# CITY OF ALBUQUERQUE

**Re: Chipotle**  
**4331 San Mateo Blvd NE Albuquerque NM 87110**  
**Traffic Circulation Layout**  
Engineer's/Architect's Stamp 10-16-2019 (G17D032)

Based upon the information provided in your submittal received 10-18-2019, the above referenced plan cannot be approved for Building Permit until the following comments are addressed:

Site Plan

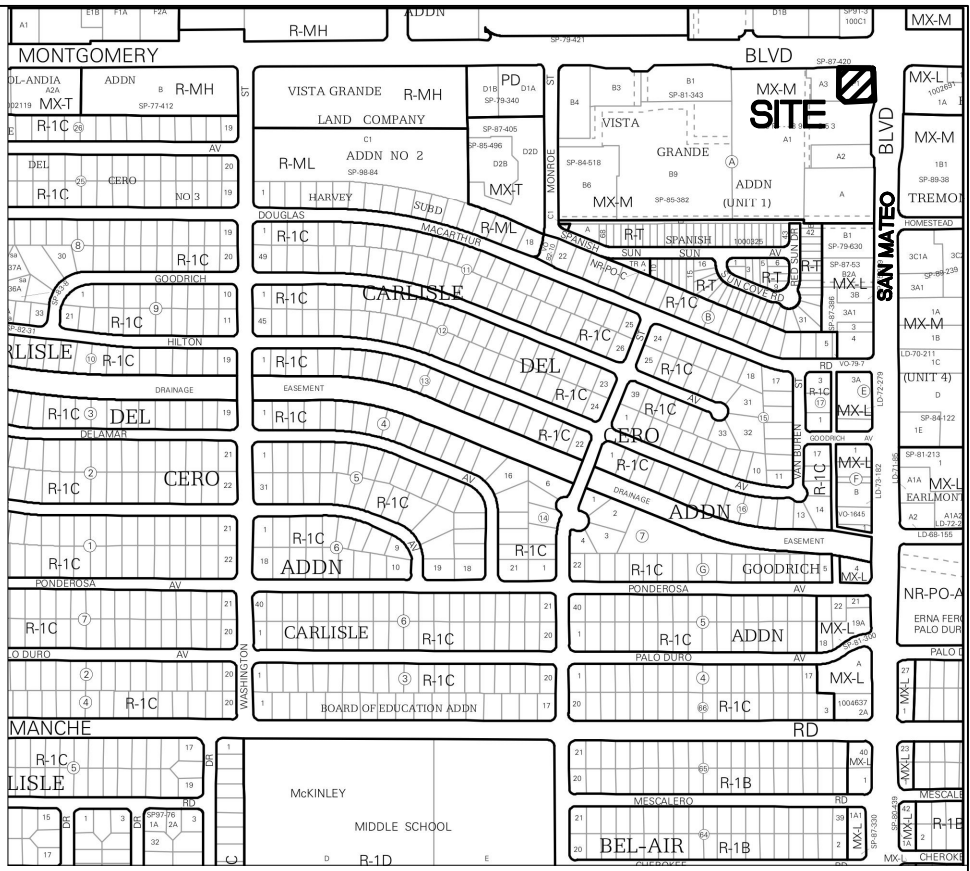
1. Refuse vehicle maneuvering shall be contained on-site. The refuse vehicle shall not back into the public right of way.; **provide a copy of refuse approval.**
2. Show the clear sight triangle and add the following note to the plan:  
"Landscaping and signage will not interfere with clear sight requirements. Therefore, signs, walls, trees, and shrubbery between 3 and 8 feet tall (as measured from the gutter pan) will not be acceptable in the clear sight triangle.
3. Shared Site access: driveways that straddle property lines, or are entirely on one property but are to be used by another property, shall have an access easement. Please include a copy of your shared access agreement with the adjacent property owner.
